REMARKS

Serial No.: 09/576,560
Conf. No.: 1265

FIG. 10

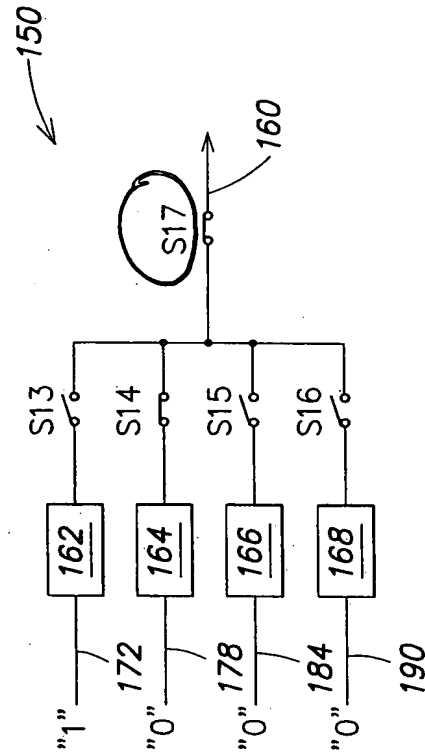
Formal drawings are submitted herewith. Applicant notes that in preparing the formal drawings, a correction has been made on Fig. 10, shown in a copy marked in red. Switch "S19" should have been Switch "S17," consistent with the labeling of that switch in other figures.
